INITIAL FIRE SAFETY INSPECTION REPORT

Explore Garments Ltd.

RSC ID: 24948

Date: 17-Dec-2023

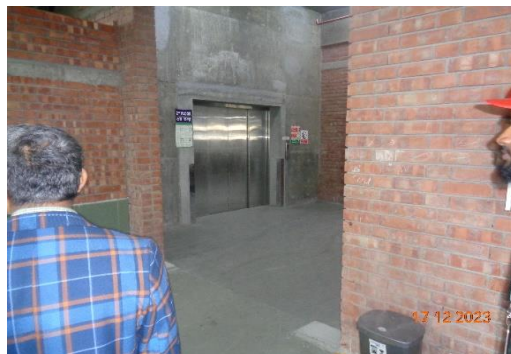
F-3	Fire Rated Construction	Unsealed penetrations and openings are located at 1st floor, 6th floor in Building-1 and utility building.	Provide a minimum 2-hr fire rated shaft to separate the utility risers from each floor level or seal all penetrations and openings in floors/ceiling assemblies by 3-hr fire rated listed/certified materials. The installation of such fire rated materials shall be following certified design.	Within 3 Months
-----	-------------------------	--	---	-----------------

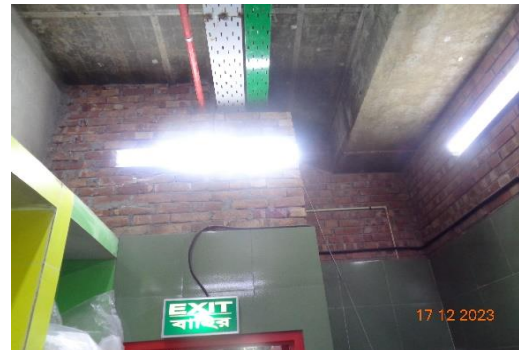
F-8	Fire Rated Construction	Chemical storage rooms located at ground and first floors are not properly fire separated from surrounding occupancies, due to openings and penetrations.	Separate the chemical storage room by 4-hr fire rated construction. Seal all penetrations and protect the openings to maintain the required fire separations. Keep 16-points MSDS of all chemicals in the storage area. Ensure that the building/room houses chemical is Type-1 construction. As per BNBC, chemical storage room shall be Type-1 construction (Table-3.2.4 of BNBC-2006). Follow section-2.13 and Table 3.2.1 of BNBC-2006 for the guideline.	Within 3 months
-----	-------------------------	---	---	-----------------
